**Re: 13107 Refurbishment of Parry Sound CCG Base
PV Panel Structural Feasibility Study**

**13107 REFURBISHMENT OF PARRY SOUND
CCG BASE
PV STRUCTURAL FEASIBILITY STUDY**

PROPOSED PV LAYOUT

SK-1

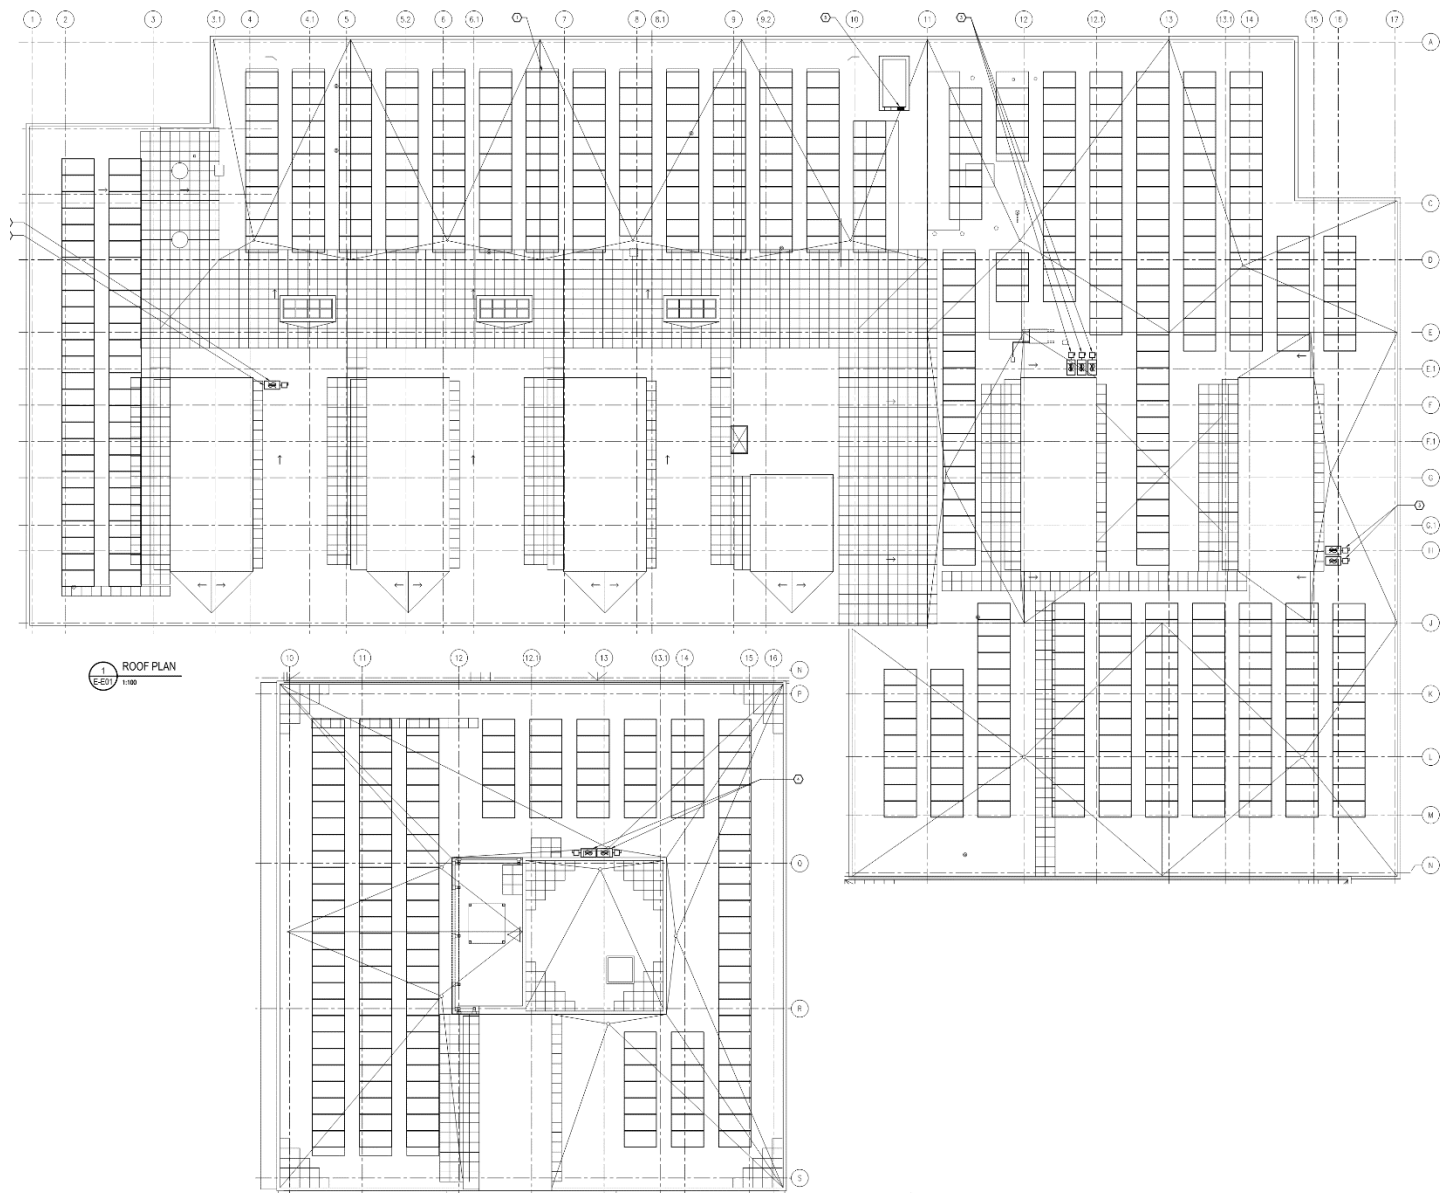
Please note that the additional load of the PV system must be uniformly distributed on each existing joist. PV panels shall not be installed on a joist which is already supporting a rooftop unit. It is our understanding that the above information will be used to generate preliminary PV layout drawings which will be provided to us for review. Please refer to the attached sketch SK-1 for a summary of the PV panel layout.
